PRODUCT CHANGE NOTIFICATION (PCN)

AMJE0909-0200-WHB-24
MODULAR CABLE

CHANGE NOTIFICATION: PCN 20220509_AMJE0909-0200-WHB-24

DESCRIPTION OF CHANGES:
CHANGE OF DATA SHEET
CHANGE OF DATA SHEET
New Draw.-No. ASS_7945_CArev02

AMJE0909-0200-WHB-24 OLD VERSION

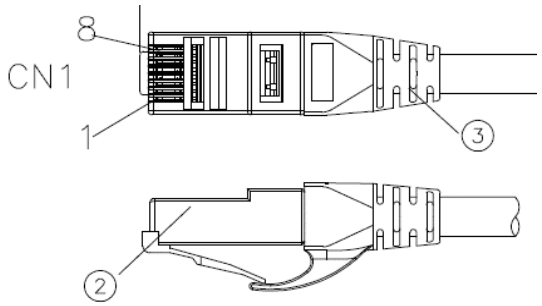
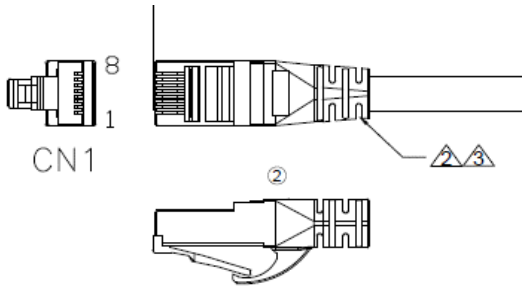
③	Molding	PVC 45P Color: see order code	NA	KG
②	CONNECTOR	RJ45 8P8C two fork Short type 3u" gold plated	2	PCS
①	CABLE	CAT6 UTP (24AWG*1PR)*4+PVC OD=5.8±0.3MM Color: see order code	NA	MM
NO:	NAME	DESCRIPTION	Q'TY	UNIT

3	Molding	PVC 65P Color: see order code ②	NA	KG
2	CONNECTOR	RJ45 8P8C PLUG 3u" gold plated ②	2	PCS
1	CABLE	CAT6 U/UTP (24AWG*1PR)*4+Cross+PVC Jacket OD=5.8± 0.3MM Color: see order code ②	NA	MM
NO:	NAME	DESCRIPTION	Q'TY	UNIT

Drawing-No.
ASS 7945 CA

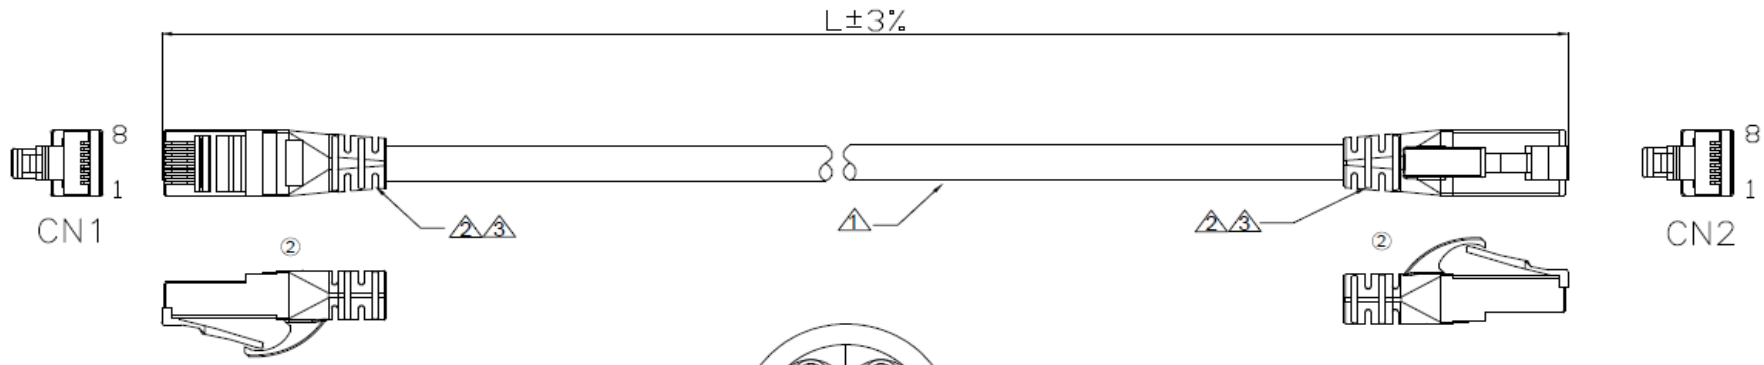
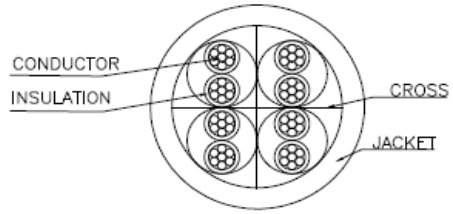
Id.	Modification	Date	Name
②	Change the plant	09.05.2022	Luca
①	Update the WSW order code	02.06.2017	Amy
⓪	Drawn	30.03.2017	Amy

NO:	NAME	DESCRIPTION	Q'TY	UNIT
3	Molding	PVC 65P Color: see order code ②	NA	KG
2	CONNECTOR	RJ45 8P8C PLUG 3u" gold plated ②	2	PCS
1	CABLE	CAT6 U/UTP (24AWG*1PR)*4+Cross+PVC Jacket OD=5.8± 0.3MM Color: see order code ②	NA	MM
